# **OWNER**

TVA ARCHITECTS 920 SW 6th Avenue Suite 1500 Portland, Oregon 97204

FREMONT APARTMENTS
lincoln property company
DESIGN REVIEW # LU 16-278621 DZ GW

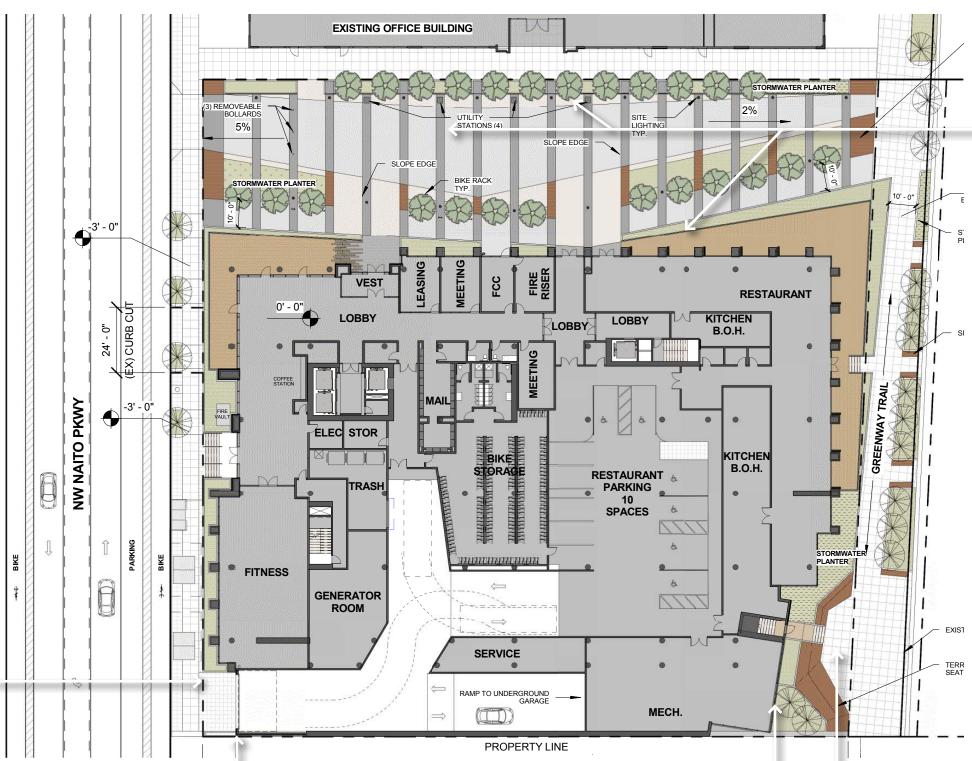
"The stormwater planter in the northern courtyard should be rotated to be east-west rather than northsouth, allowing more useful and accessible space for people."

"The bench and berm at the east end of the courtyard should be lower or removed to be able to see the river as a terminus."

the planter has bee redesigned and is now oriented in the east-west direction along the northern property line

the bench and berm in question have been removed in the redesign of this area
